TITLE: GTA04b7

Date: 03.10.14 23:14

## Buttons

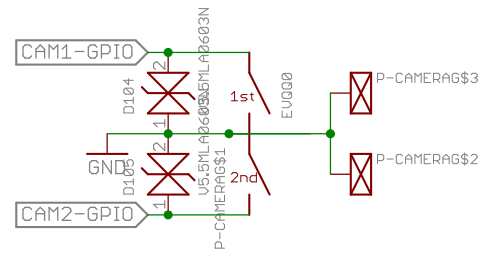
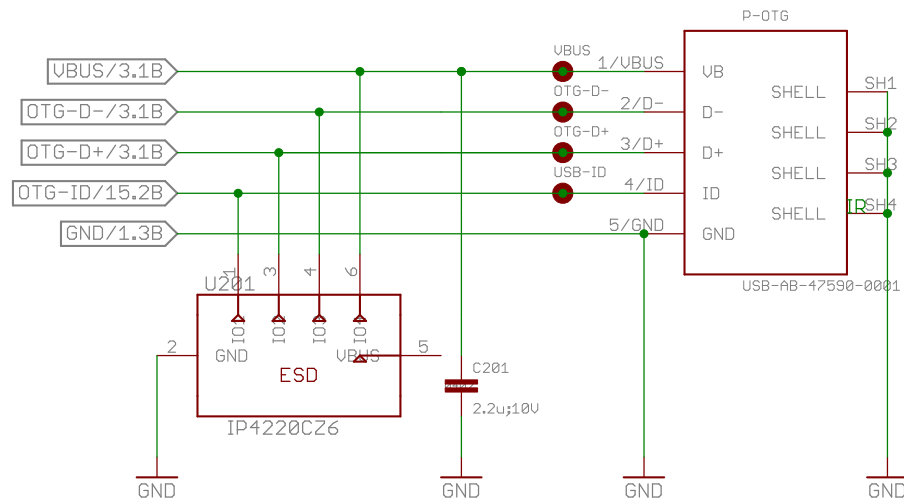
place in scan matrix? would need 3-4 wires to UPPER board instead of 2!  
 No. VOL+ or VOL- can either be connected to GPIOs  
 or drive two FETs that sit in the keyboard matrix  
 in any case it is sufficient to connect GPIO-VOL+ and VOL- to two pins on the B2B connector

## OTG

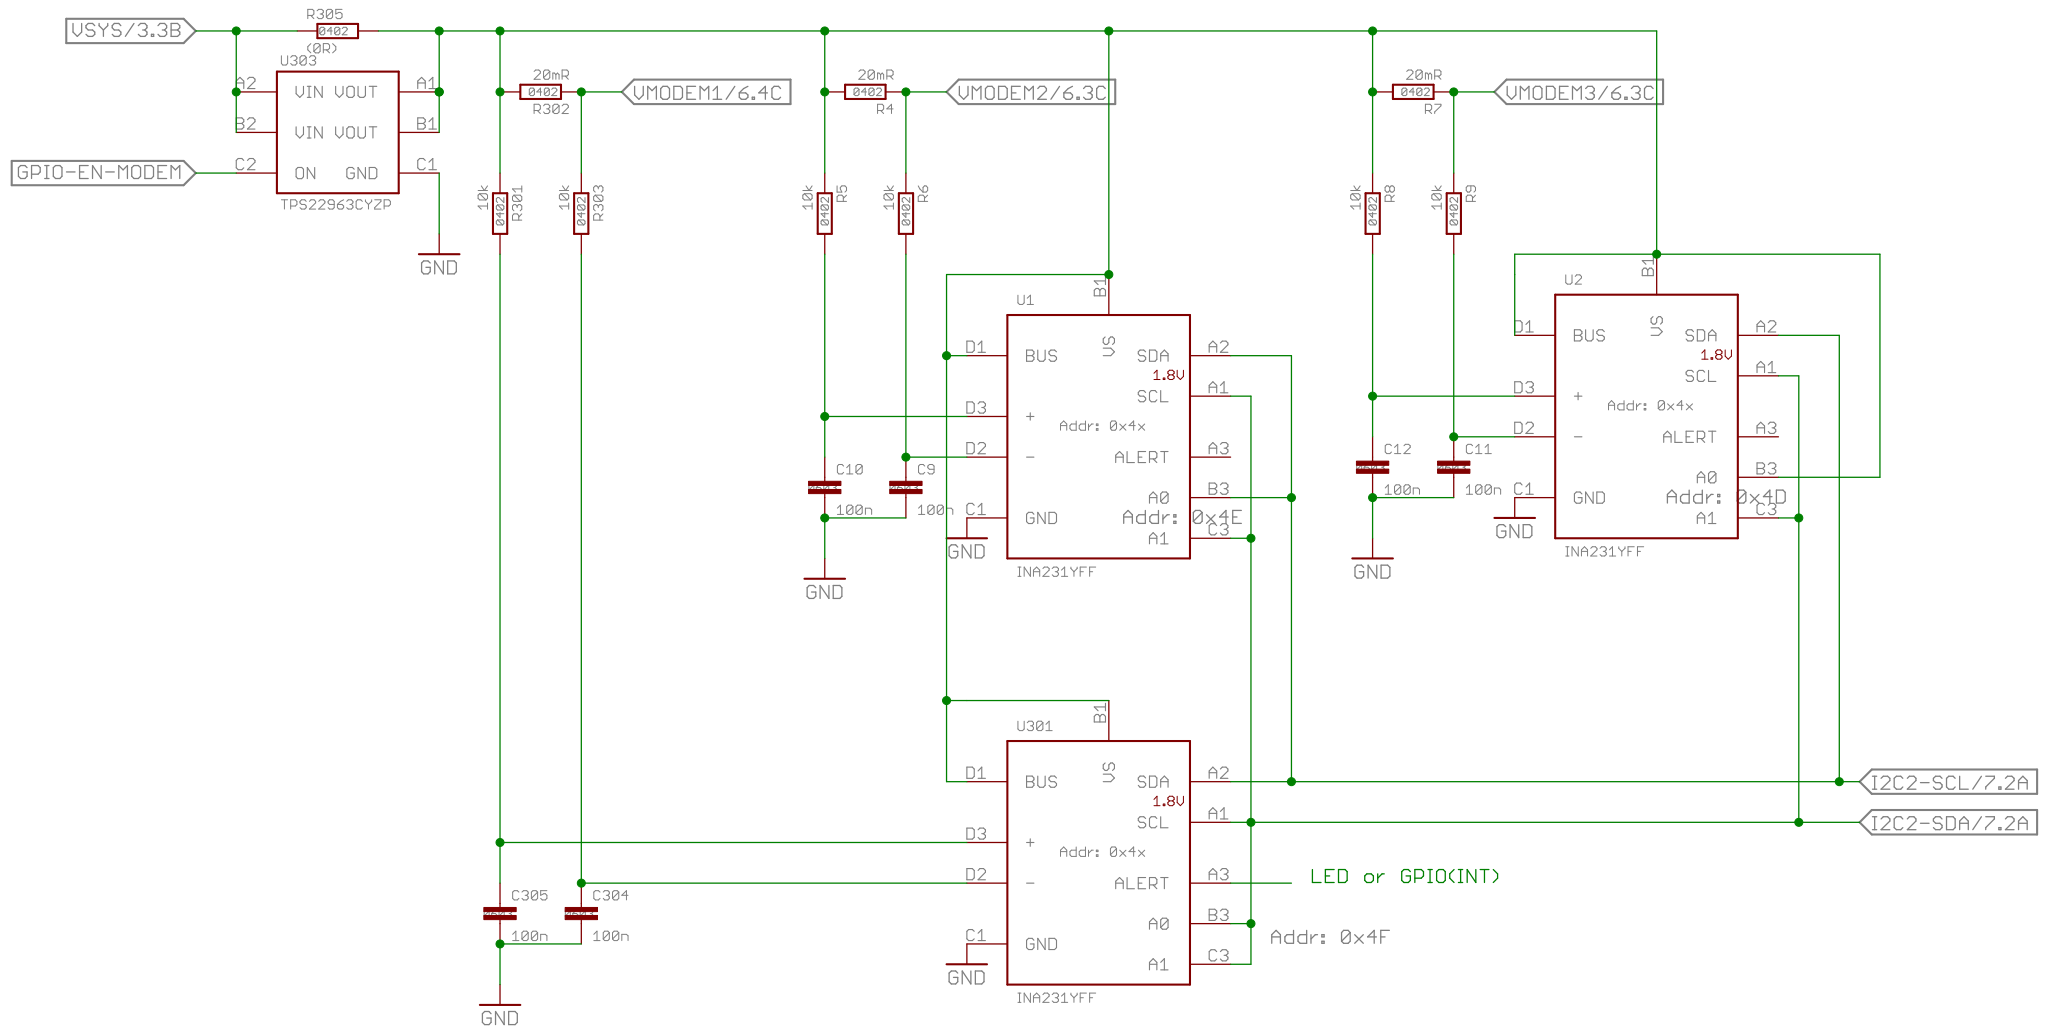
Layout: place test points in battery bay

# Fuel Gauge

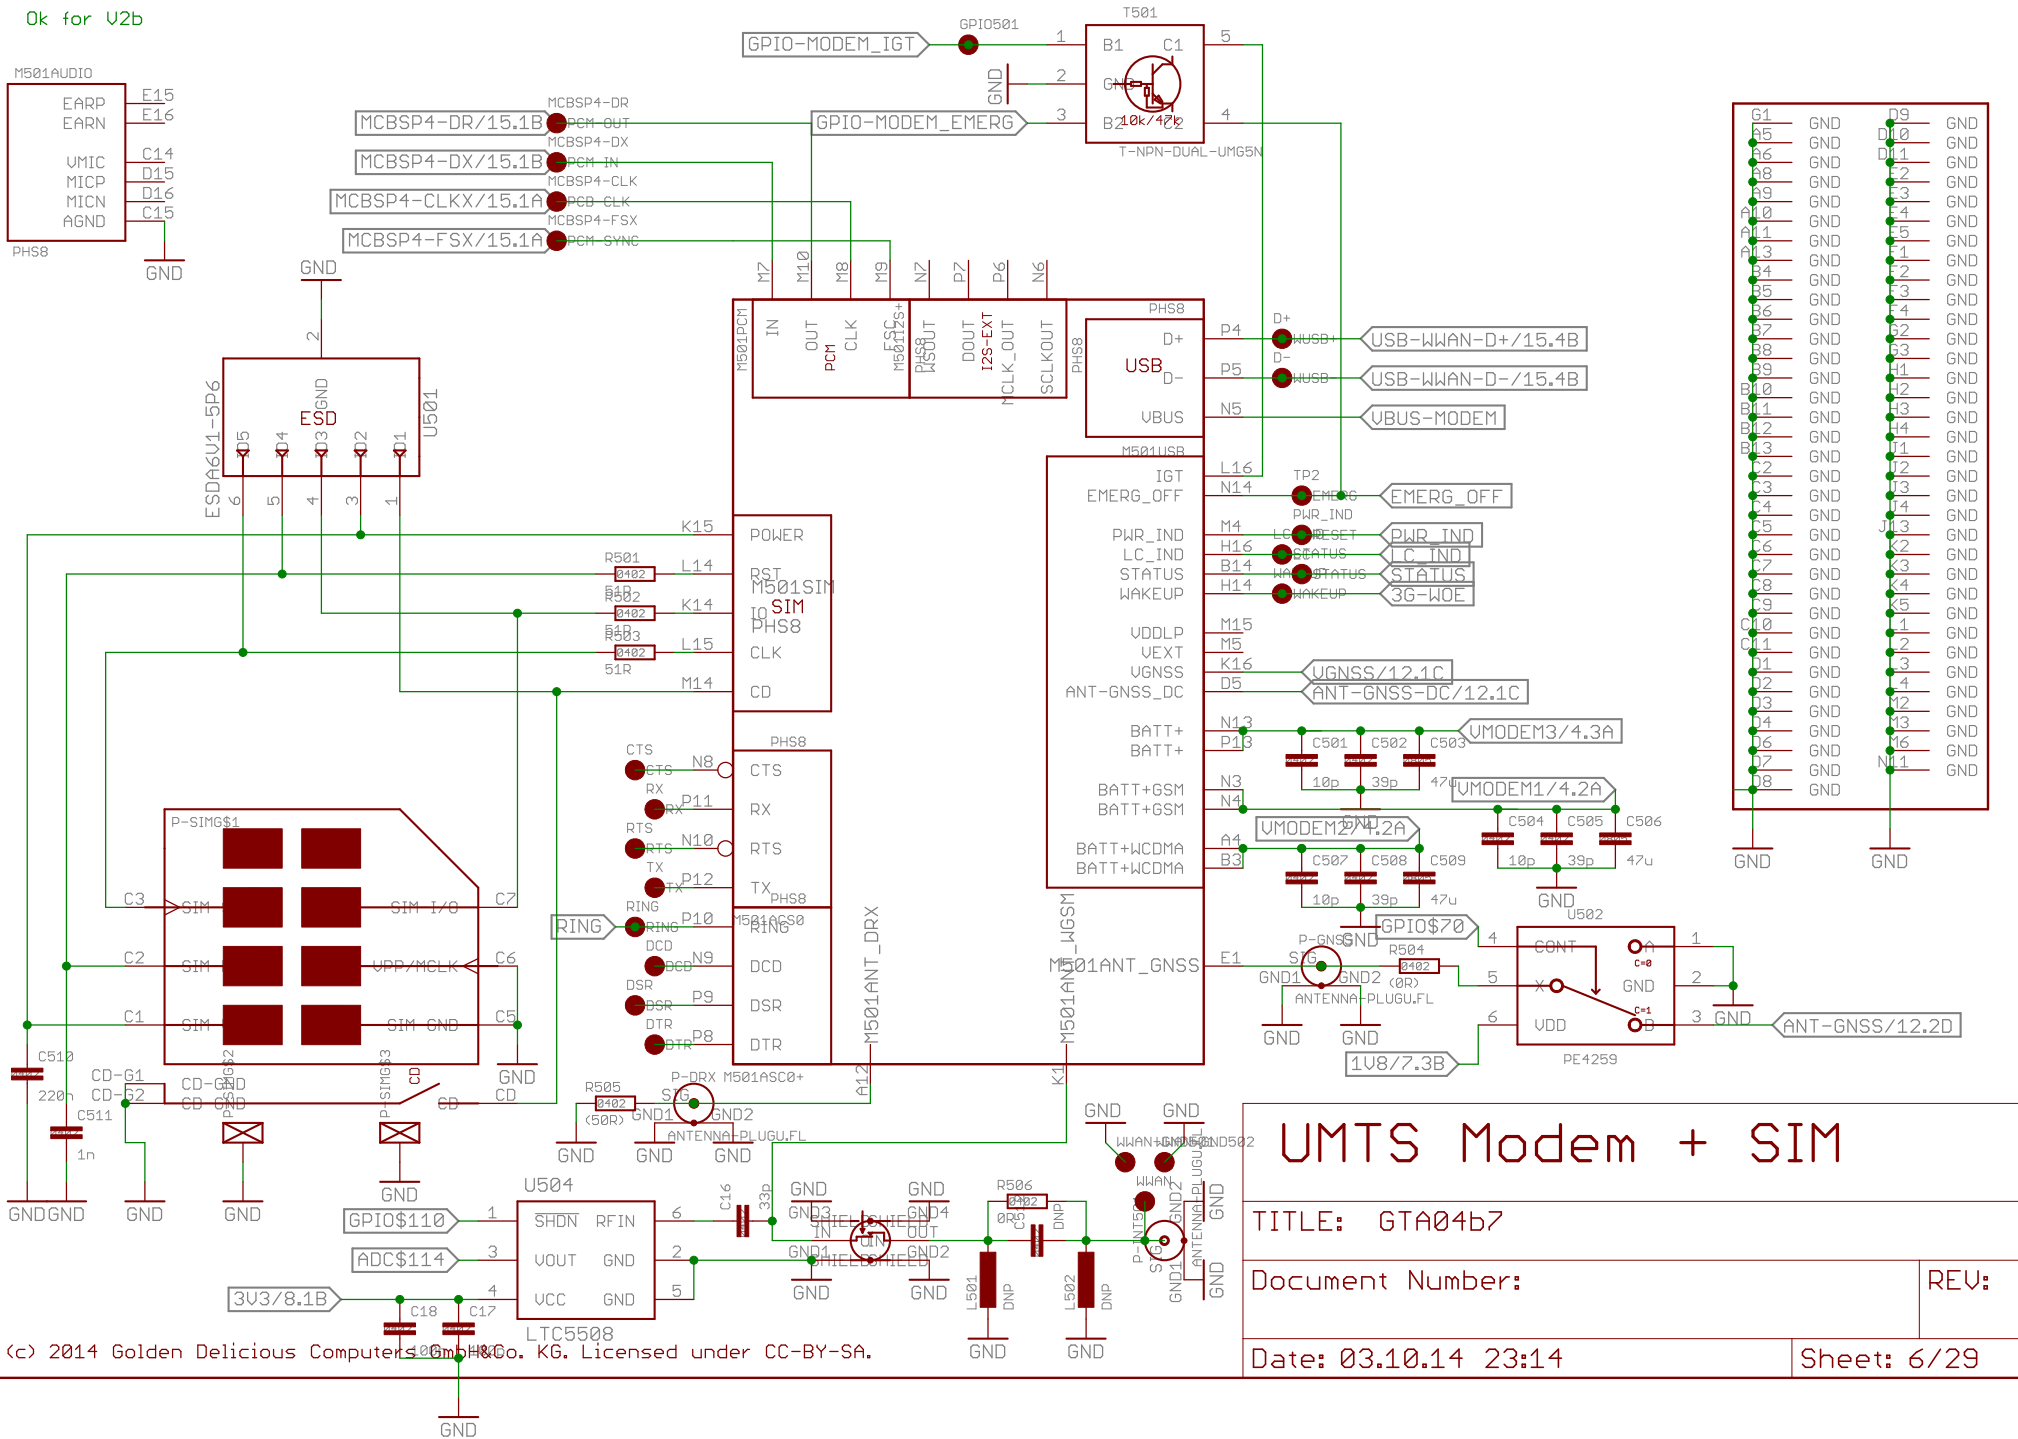
auf Upper schieben?

battery cage to GND?

# Sensors

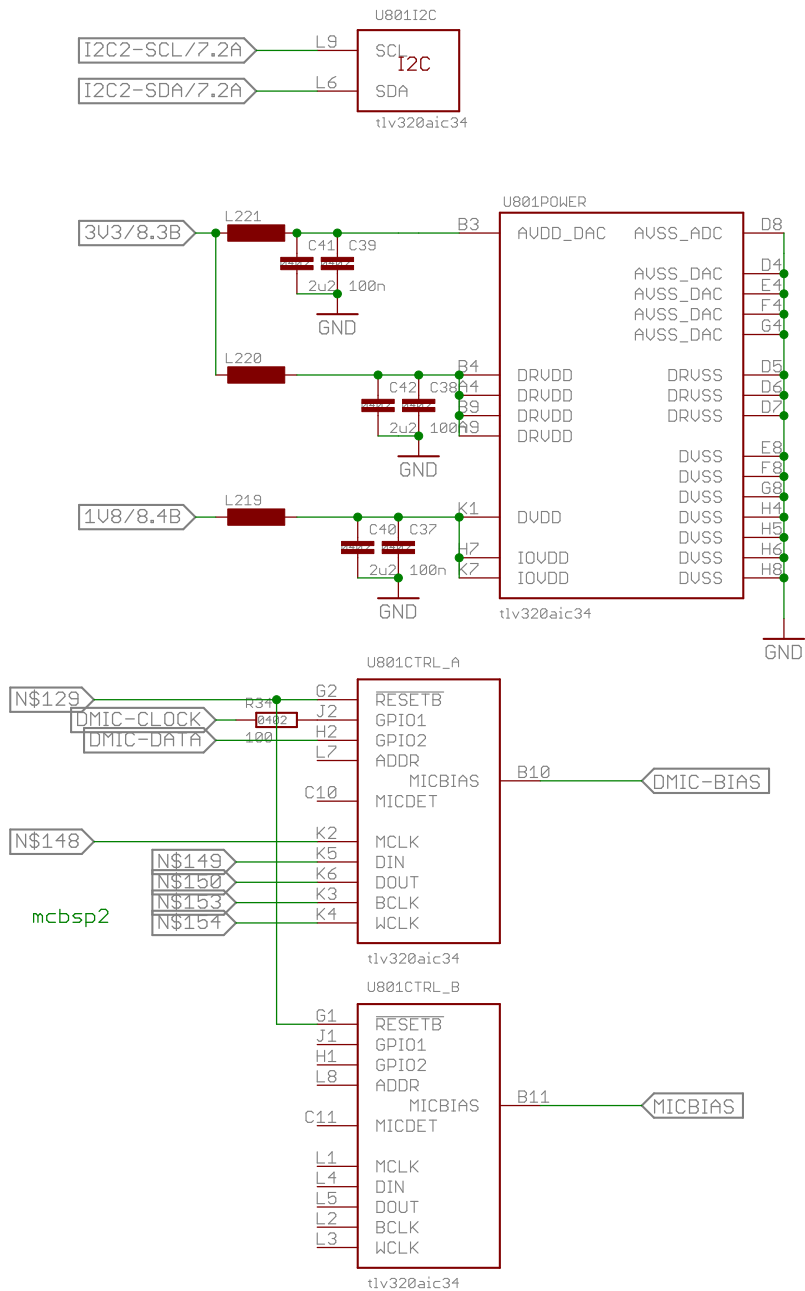
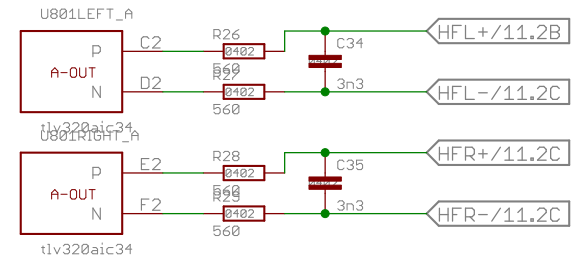
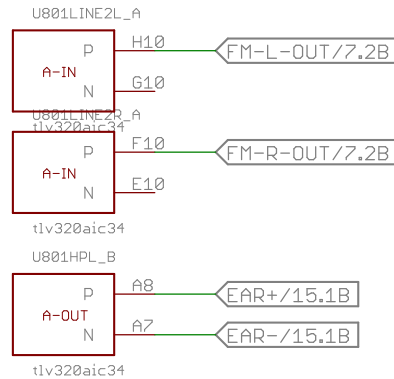
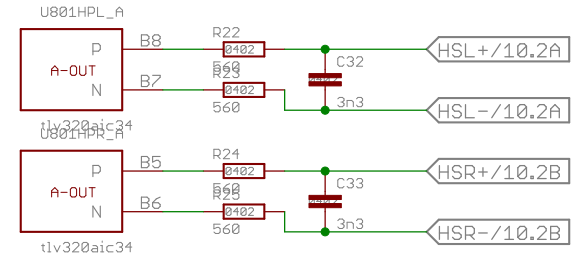
conflict with bmc150?

address: 0x18-0x1b

<h1>Audio Codec</h1>	
TITLE: GTA04b7	
Document Number:	REV:
Date: 03.10.14 23:14	Sheet: 9/29

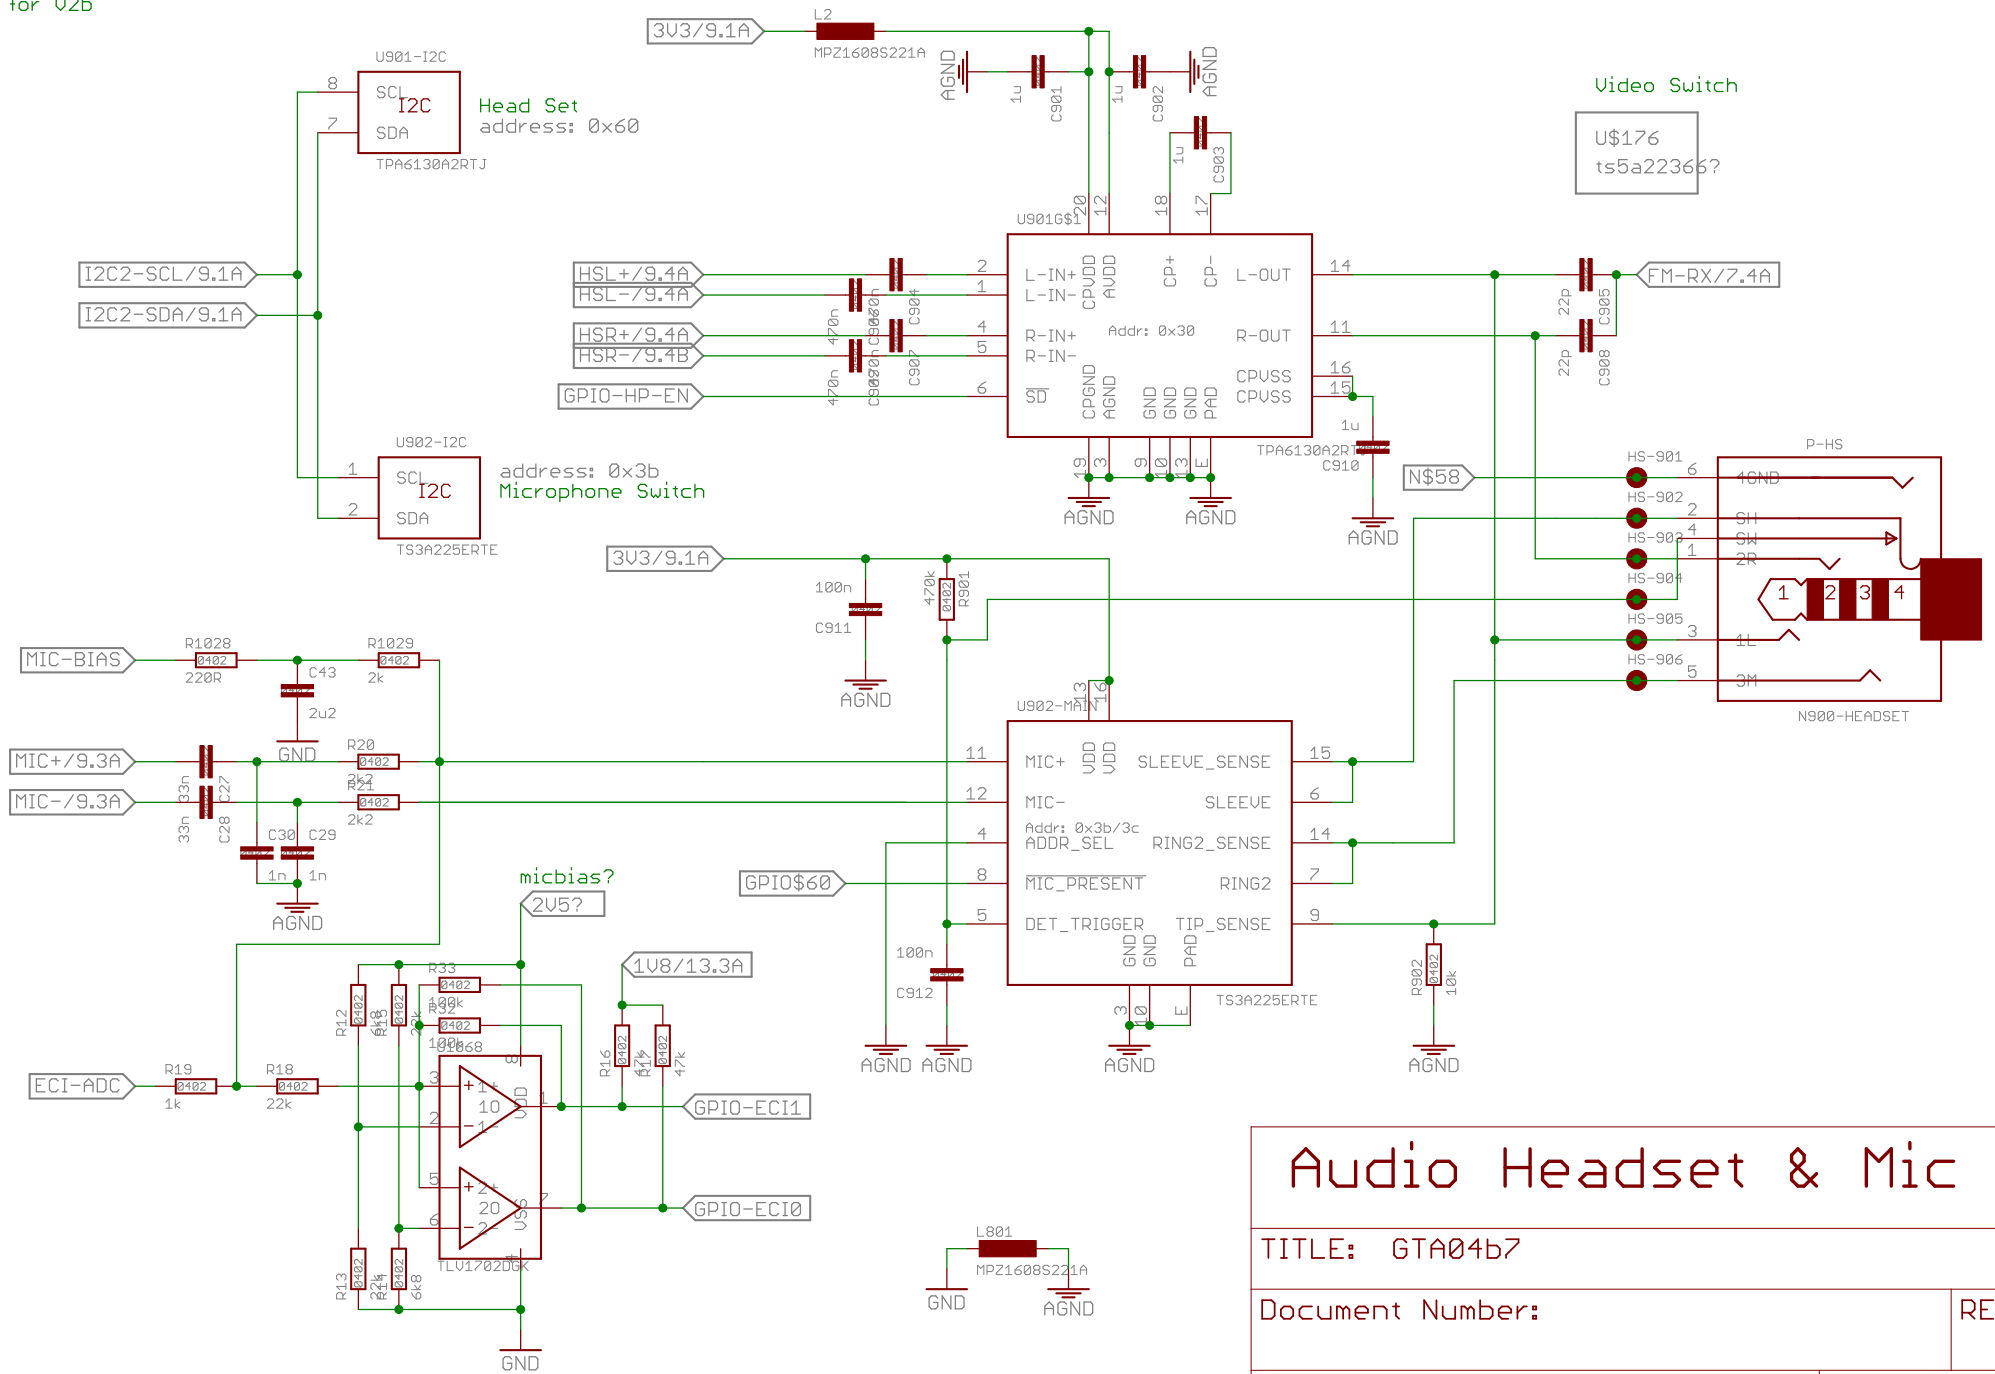
problem: this is a 0.5mm BGA making lower board expensive!  
but it appears to be not extremely critical (only 3 rows and inner ring is GND)  
problem: analog mic is on upper board!  
alternative: place on upper board (to be evaluated)

# Charger/Console

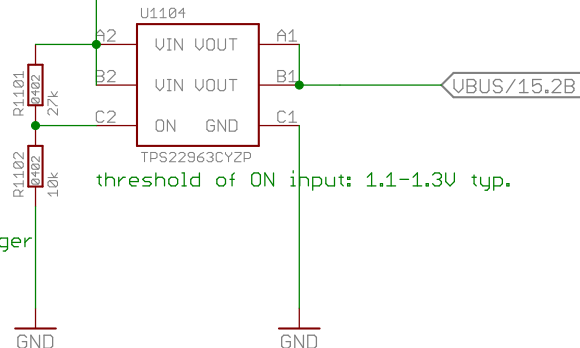
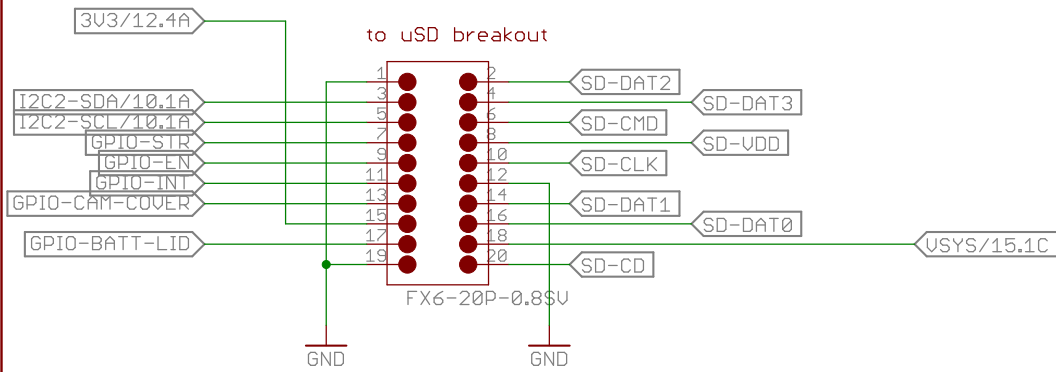
replace by tpd4s012dryr? less space?

CBUS can't be easily used as GPIOs

do we need to control D+/D- of USB3 to enable high charging current?

latchup risk by reverse current? (limited to 2.1 uA)

may need controller!  
make threshold@4.5V

threshold of ON input: 1.1-1.3V typ.

not needed if we use BQ24161B charger  
has 2 separate power inputs
